# 9.0 RESPONSES TO COUNCIL FEEDBACK

# SUMMARY

## DRAWING SET 45 McLAREN STREET, NORTH SYDNEY

# ARCHITECTURAL SET AMENDED PP

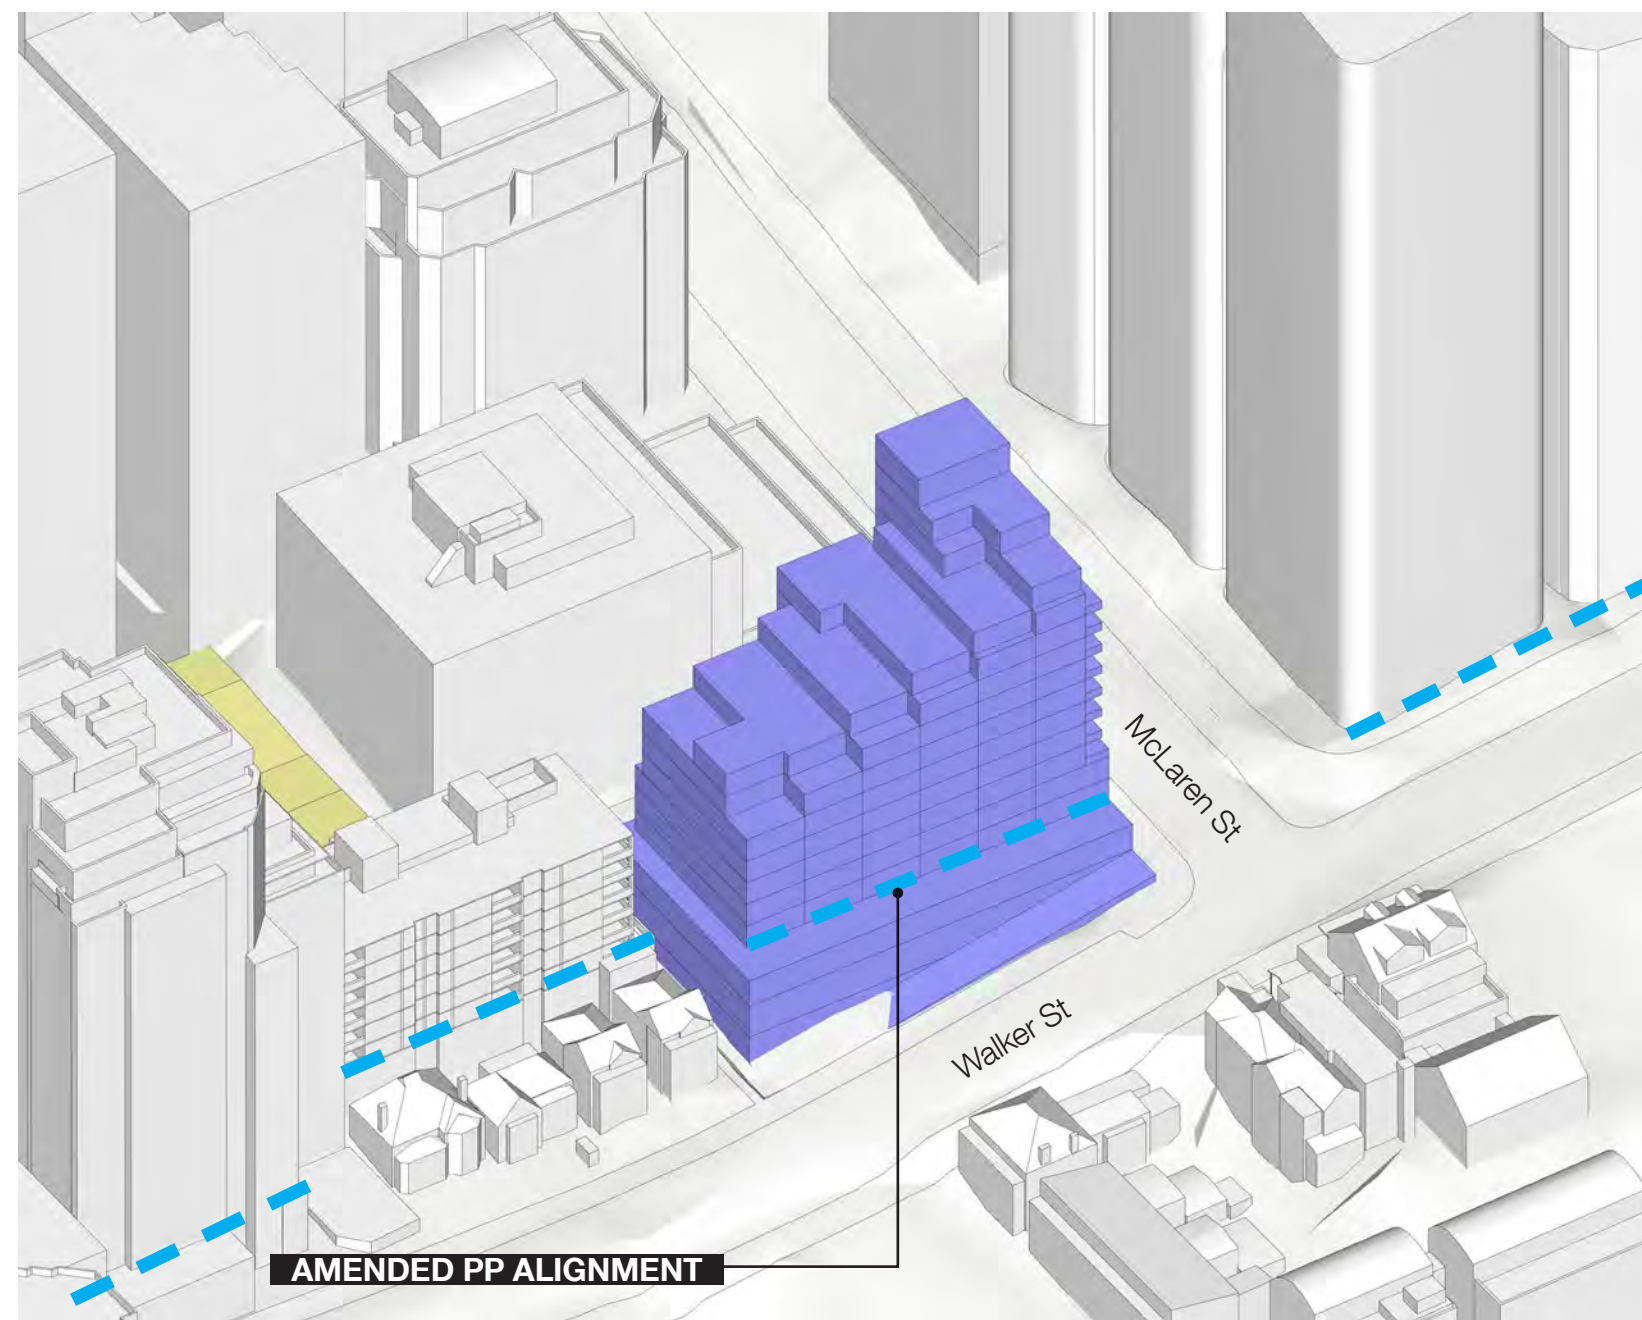
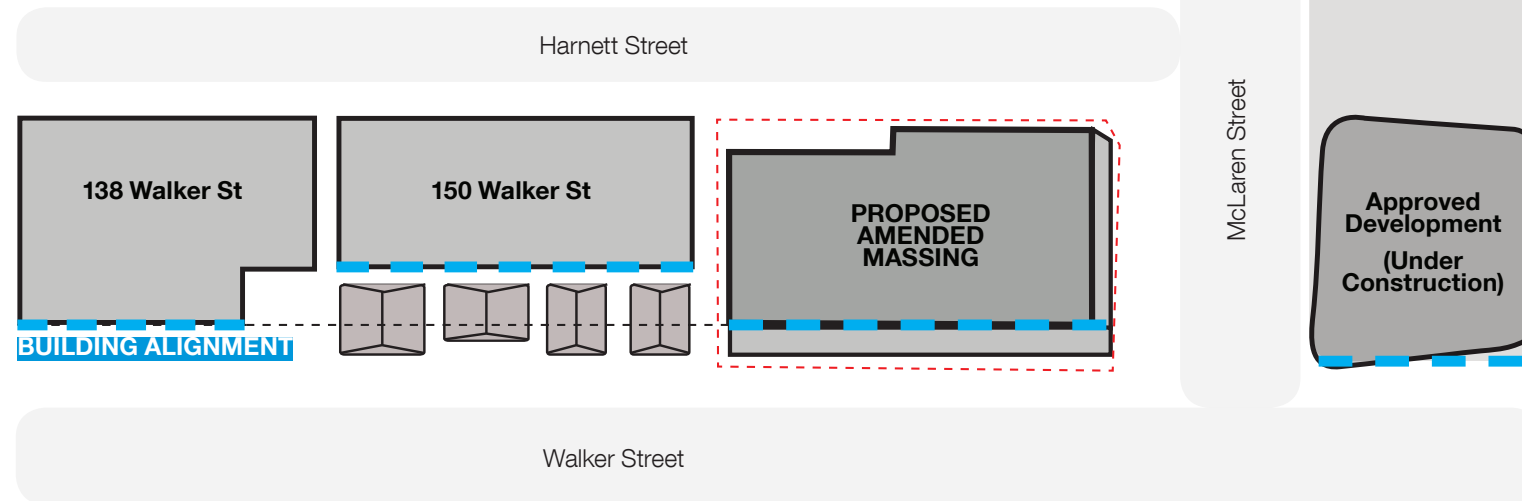
That the concept proposal be revised to:

Upper levels of tower stepped in plan and elevation in response to form and to maintain good solar access to 150 Walker Street

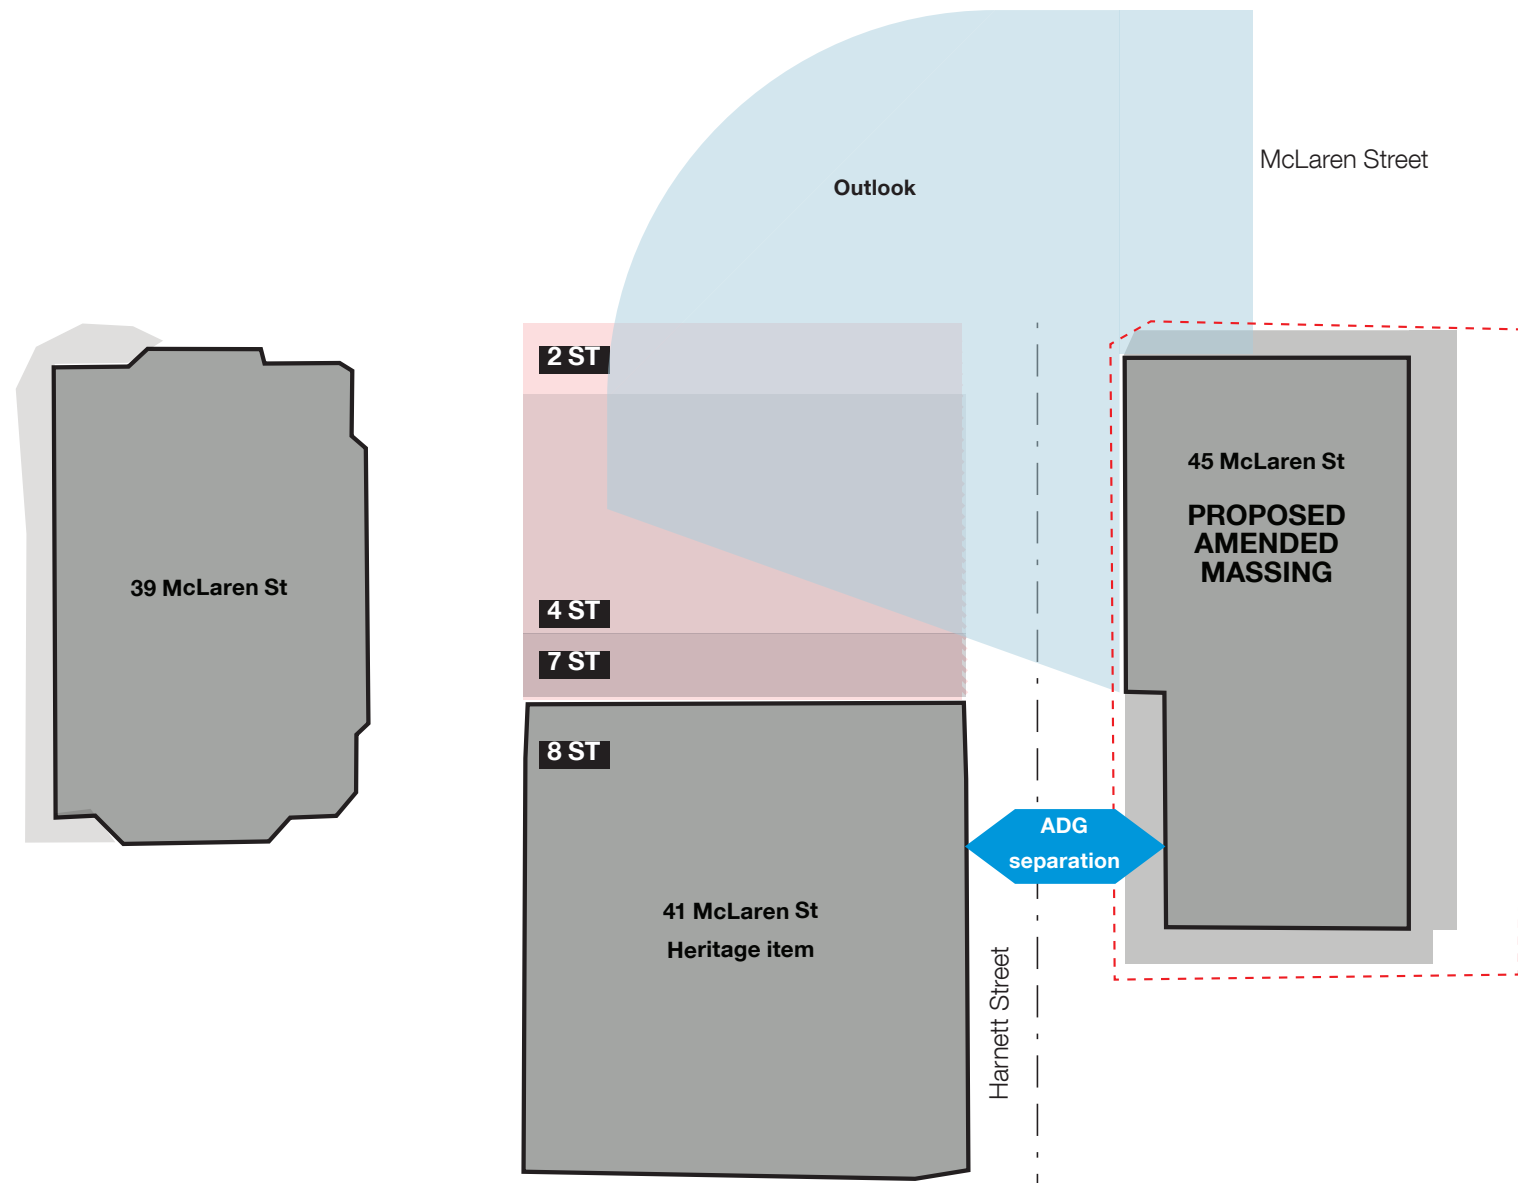
That the concept proposal be revised to:

The approach to building separation, ADG compliance, and ensuring high levels of residential amenity includes the following strategies:

- Tailored response that recognises the importance of heritage listed built fabric at 41 McLaren Street including the stepped form and integral facade screening
- Setbacks to the proposed development at 45 McLaren St respond to the different scale of 41 McLaren St
- ADG compliant setbacks are provided to the southern portion adjacent the 8 storey component range
- A reduced setback is provided to the northern portion adjacent the lowscale section of the heritage building.
- Apartments within the reduced setback zone (2 per floor) benefit from outlook over the adjacent building as well as oblique views along Harnett Street to the north and south. Both are corner units providing dual aspect.

### Harnett Street Setback - "address ADG separation requirements"

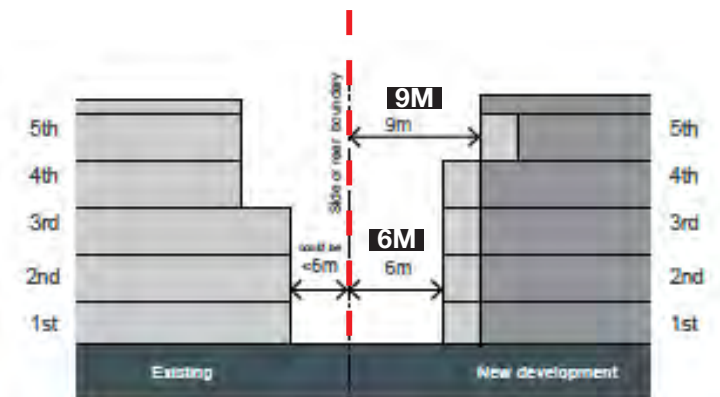
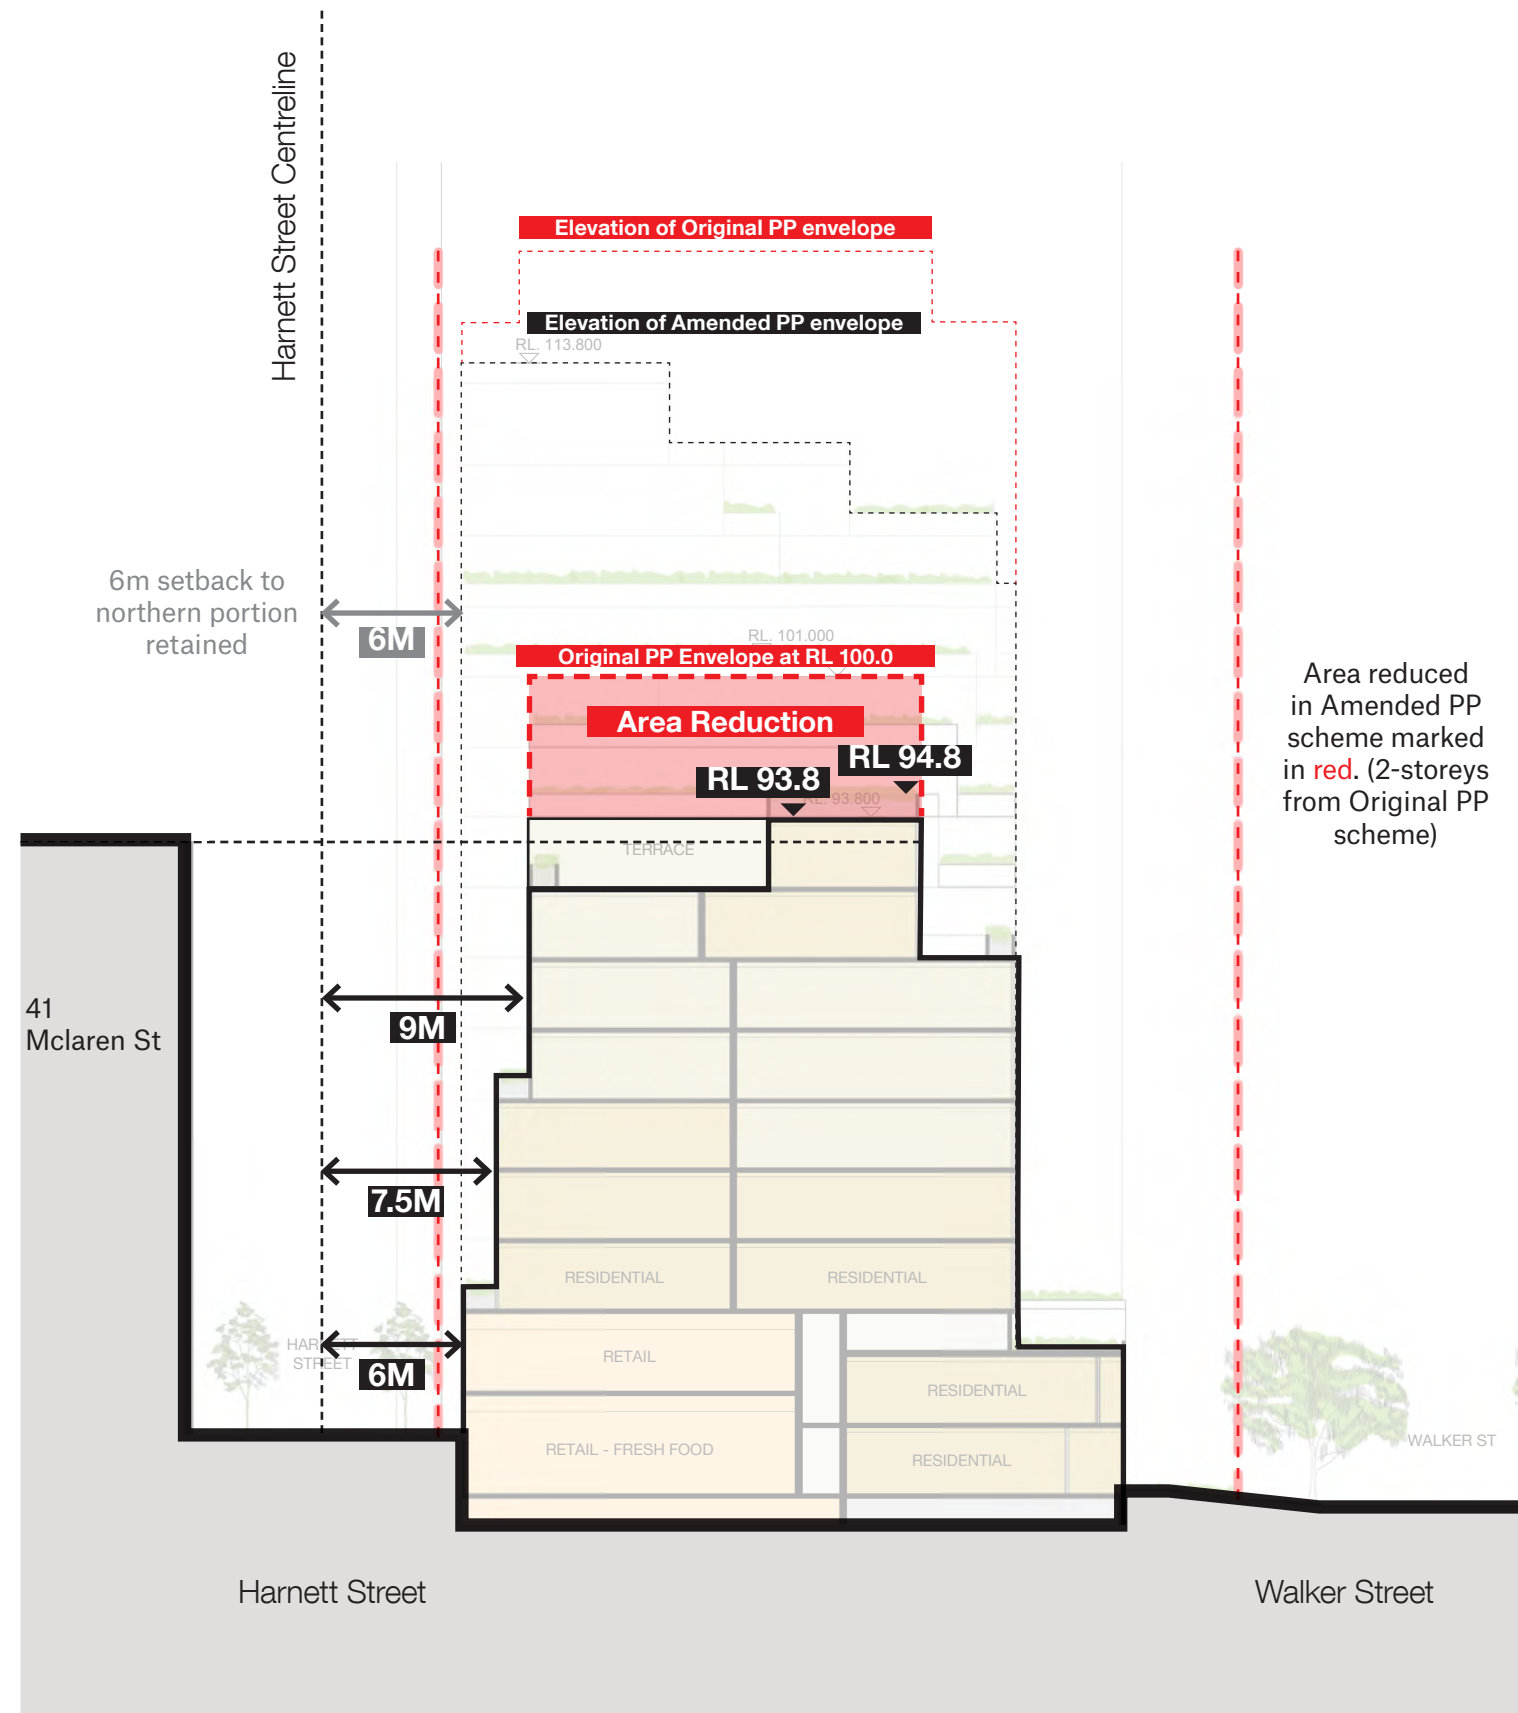
That the concept proposal be revised to:  
 (c) ensure that it is appropriately setback from the southern and western boundaries consistent with the minimum requirements set by the Apartment Design Guide to ensure adequate amenity to adjoining properties and internally within the development;

Revised massing has resulted in significant height reduction, with majority of the development adjacent 41 McLaren Street limited to 8 storeys with ADG compliant setbacks.

### Harnett Street Setback - "address ADG separation requirements"

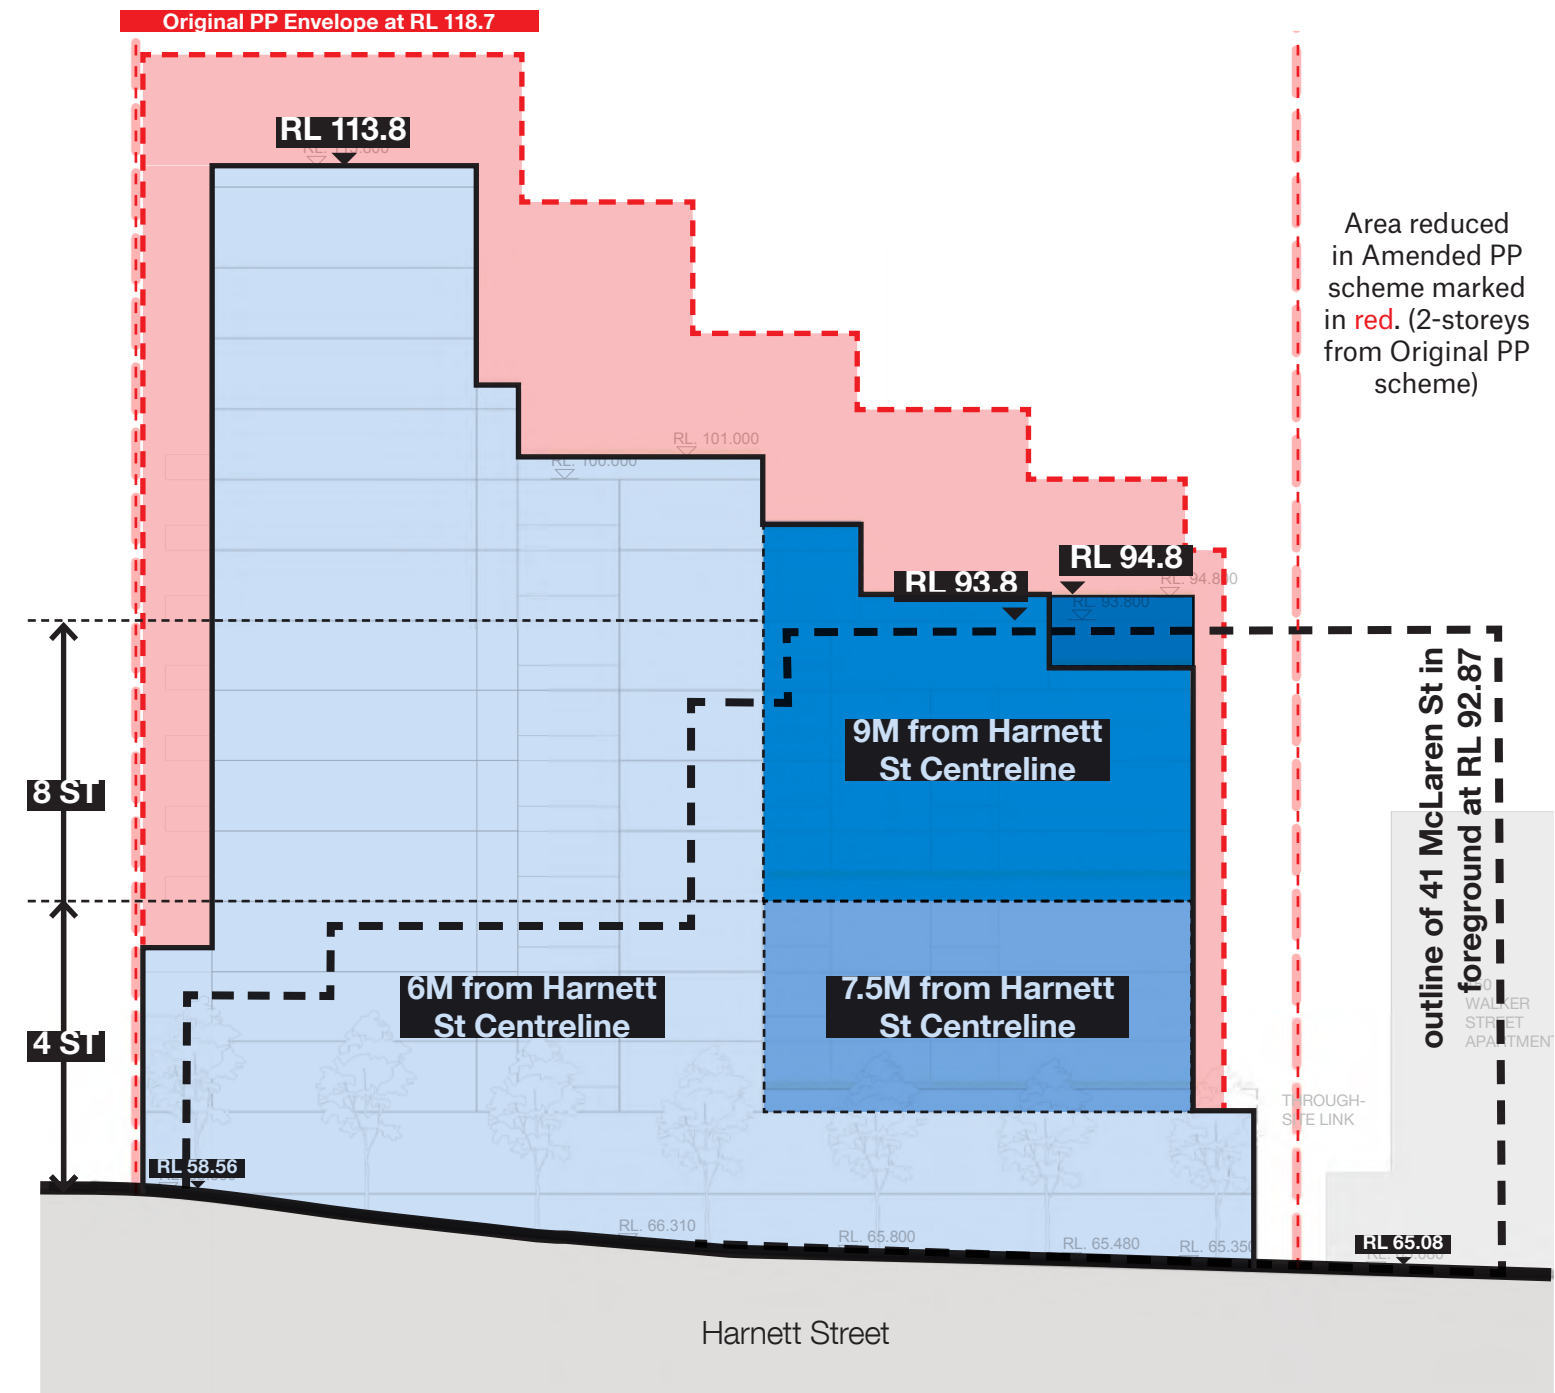
That the concept proposal be revised to:  
(c) ensure that it is appropriately setback from the southern and western boundaries consistent with the minimum requirements set by the Apartment Design Guide to ensure adequate amenity to adjoining properties and internally within the development;

- Amended PP 6m from Harnett Street Centreline
- Amended PP 7.5m from Harnett Street Centreline
- Amended PP 9m from Harnett Street Centreline
- 41 McLaren Street
- Area reduced in Amended Planning Proposal
